**Review Comments on
Summary of Soil Vapor Extraction System Expansion, 12/8/17
Hartford Petroleum Release Site
Hartford, Illinois
1/22/18**

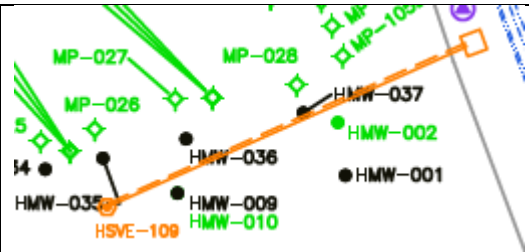
017 - 5/25/2017	NORTHING 790771.00																						
t	EASTING 2317379.07																						
	COMPLETION 5/31/2017																						
	SURFACE ELEVATION 430.42																						
	WELL TOC 430.01																						
II Installation completed	LOGGED BY T. Aseltyn																						
HSVE Well	CHECKED BY C. Martin																						
	USCS	Well Diagram																					
tent, OL																							
14	Attachment B Borehole Logs	Re: Fluid (groundwater and NAPL, if present) level monitoring of 1-inch piezometers upon installation.	If fluid levels were monitored upon 1-inch piezometer installation, indicate measured fluid levels on the piezometer logs.																				
Attachment C – Location-Specific As-Built Documentation																							
15	Attachment D As-Built Drawings, Figure C7, Detail Area A	<p>As shown below, there is a 0.25-inch stainless steel sample port at the wellhead that is in communication with internal well space.</p>	Confirm whether this 0.25-inch stainless steel sample port will be used to measure actual wellhead vacuum (inside the well) as a true measure of vacuum applied to formation.
